Falconis Acura, west Sahara -

PROJECT: Planet Mazda

CITY OF LAS VEGAS		DATE:
INTER-OFFICE MEMORANDUM		June 4, 2012
TO: Land Development Services Department of Public Works		FROM: Albert Sung, P.E. Flood Control Project Engineer Department of Public Works
SUBJECT:	Drainage Study for:	COPIES TO:
	Falconi's Acura, West Sahara – Planet Mazda	The LanDesign Consultant
Cross Streets:	NWQ of Sahara Avenue & Rainbow Blvd.	Centennial – Azure LLC
File Number:	F:\Depot\DSMemos\DS4556A.doc	Bart Anderson, P.E., DevCo
Parcel Number:	163-03-806-012 & -013	CCRFCD
Zoning Action:	PMP-45008	CCPW
FEMA Flood Zone	YES	NO X
Proposed Storm Drain	YES	NO X

UPDATE No 2
for the
TECHNICAL DRAINAGE STUDY
for
Falconi's Acura, West Sahara
and now including
Planet Mazda

DETAILS

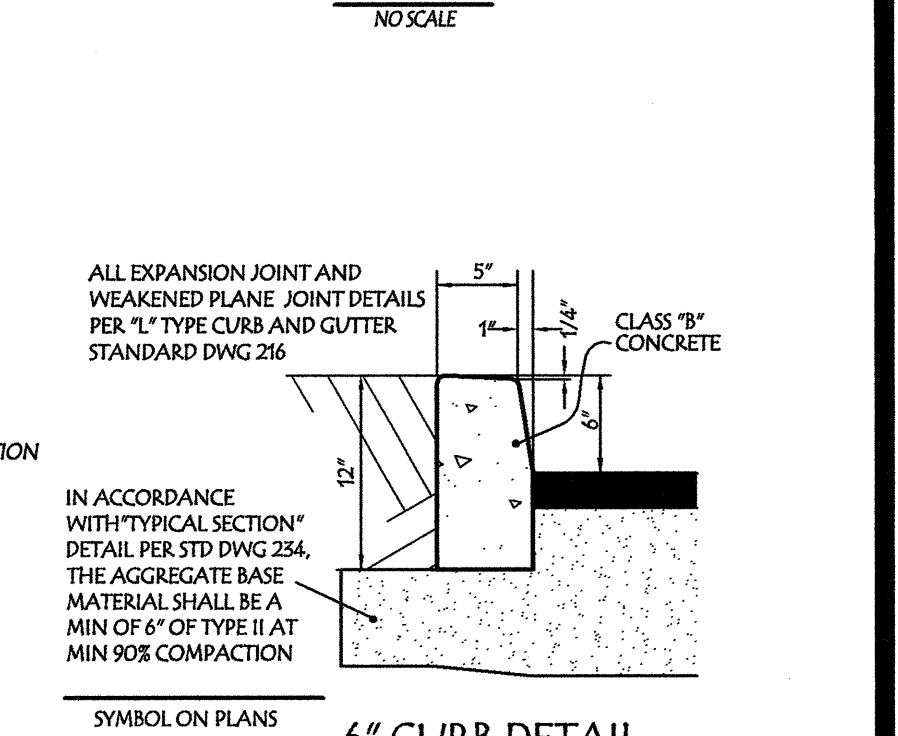
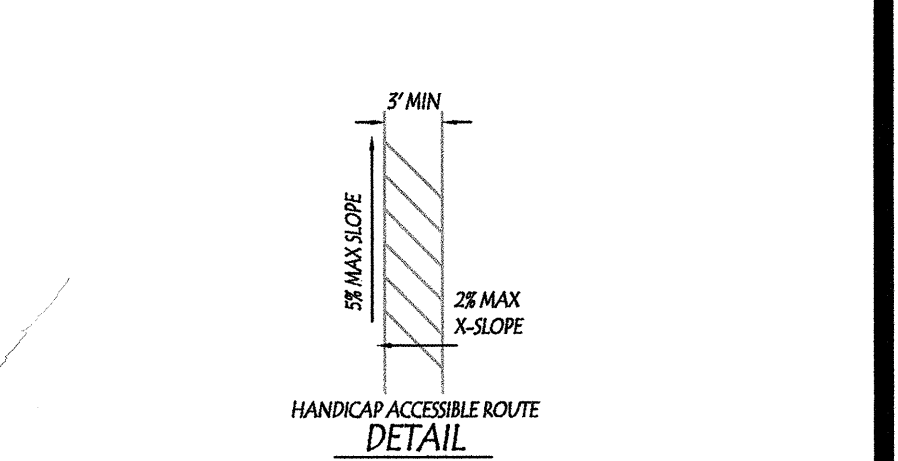
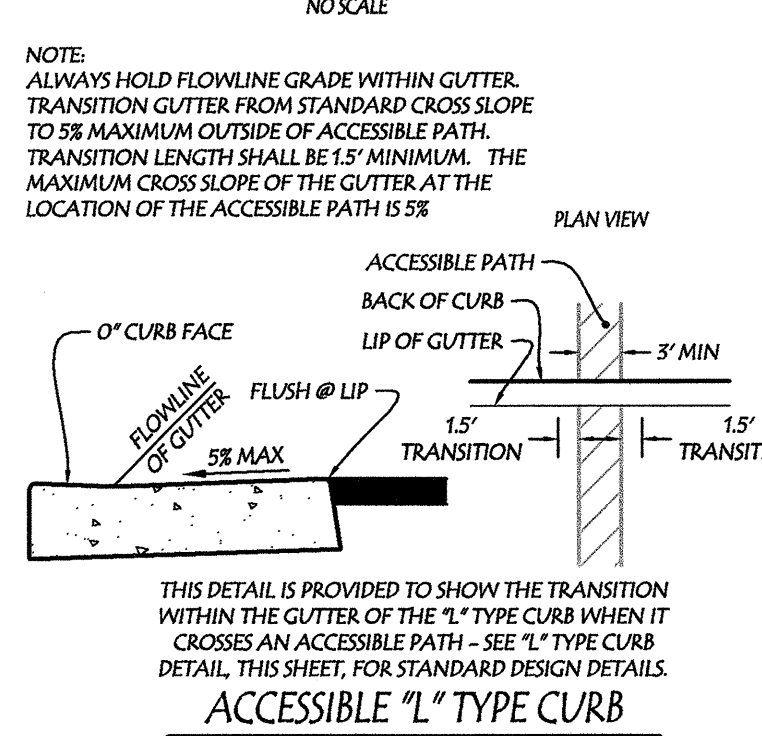
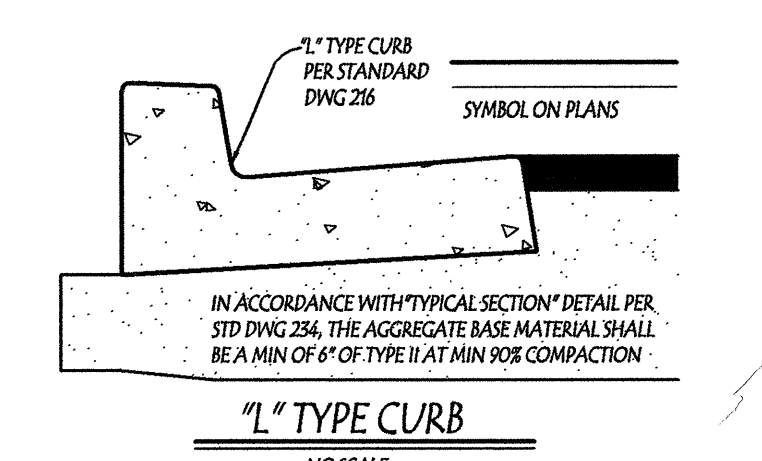
6. Revise Detail B2/7 and Detail C/7 to provide either a concrete valley gutter or a "U" channel adjacent to the proposed retaining wall to flood proof the wall from inundation. Show the "V" or "U" on the grading plan in the pertinent locations with flow line elevations at regular intervals accordingly.
7. A "North Arrow" has been shown on the grading plan, however, a "Scale Bar" is missing. Provide as such in the grading plan in the next submittal.
8. It appears that *Via Olivero Avenue* is not within the scope of the project. It is not necessary to include the street cross section. Review and remove in the next submittal.
